MEMORANDUM

SUBJECT: Ashton Village Center Sector Plan

PURPOSE: Worksession to development recommendations for Council consideration

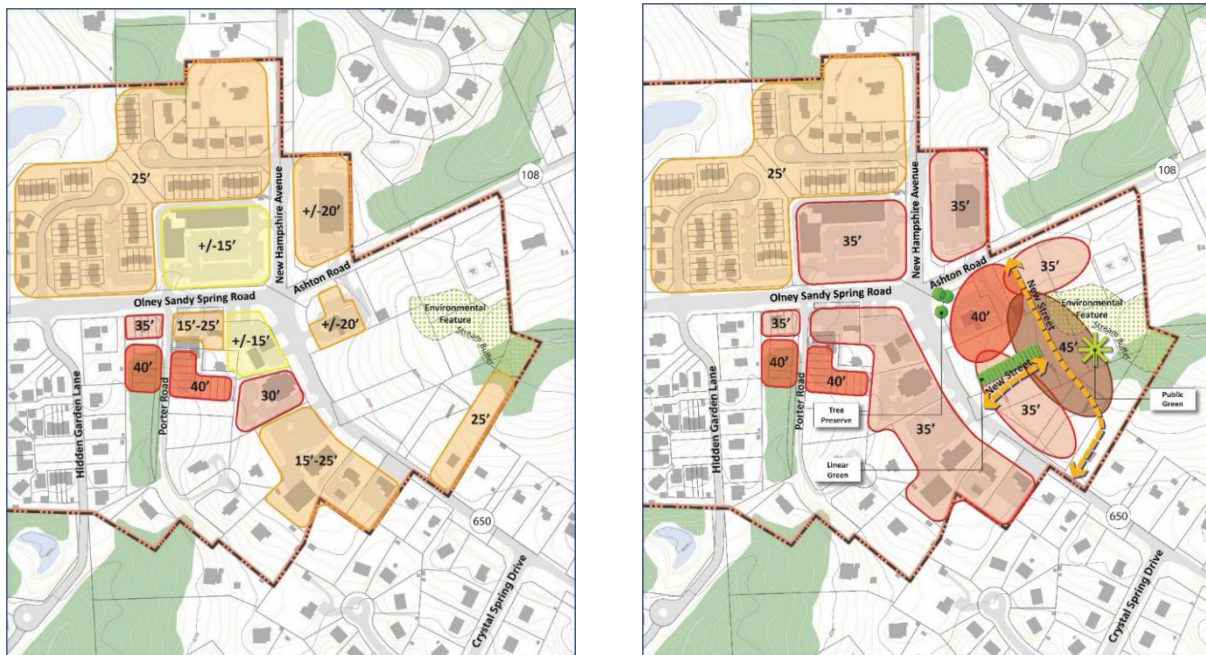
1. Clarify that height bubbles in Figure 4 show suggested development pattern, not maximum building heights.

Figure 4, reproduced below, includes a series of ovals that could be viewed as imposing rigid height limits in various sectors of the SE Quadrant Property. The Planning Board discussed building height for this site extensively, and nothing in that discussion suggested that building heights should be limited to 35 feet in any given location, or that buildings of similar height should be clustered together in certain areas. On the contrary, the Sector Plan specifically recommends that building heights vary from one building to the next. Moreover, the focus of discussion before the Planning Board was on creating appropriate transitions to surrounding development, with lower building heights at the edges and higher building heights at the corner and in the interior of the site.

To avoid circumscribing building heights in a way that will be counterproductive and inconsistent with other elements of the Sector Plan, the caption of Figure 4 should be revised as follows:

Figure 4. Existing building heights (left) and **suggested development patterns** ~~maximum-proposed building heights~~ (right) in the Village Core neighborhood and surroundings. ~~Figure 4 includes, including~~ suggested building heights for buildings in the southeast quadrant showing the tallest buildings in the interior of the quadrant and maintaining a transition along the state highways, **but this exhibit is not intended to limit specific building heights in any location except as required in other sections of this Plan.**
